February 11, 2022

To the members of the Planning Board,

I would like this correspondence to go on record as a recap of open issues & of newly discovered ones regarding the Maritime Haven commercial project.

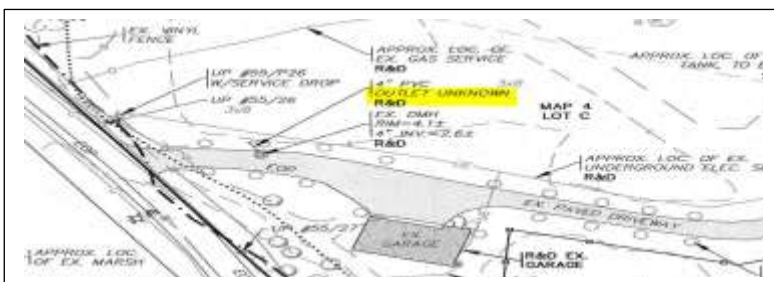
13. There is a drainage catch basin that currently takes run-off water from Robinwood Rd., as shown above. Where the water goes is marked "unknown." We should know where the water goes to avoid flooding on Robinwood Rd. and this should be corrected if necessary.
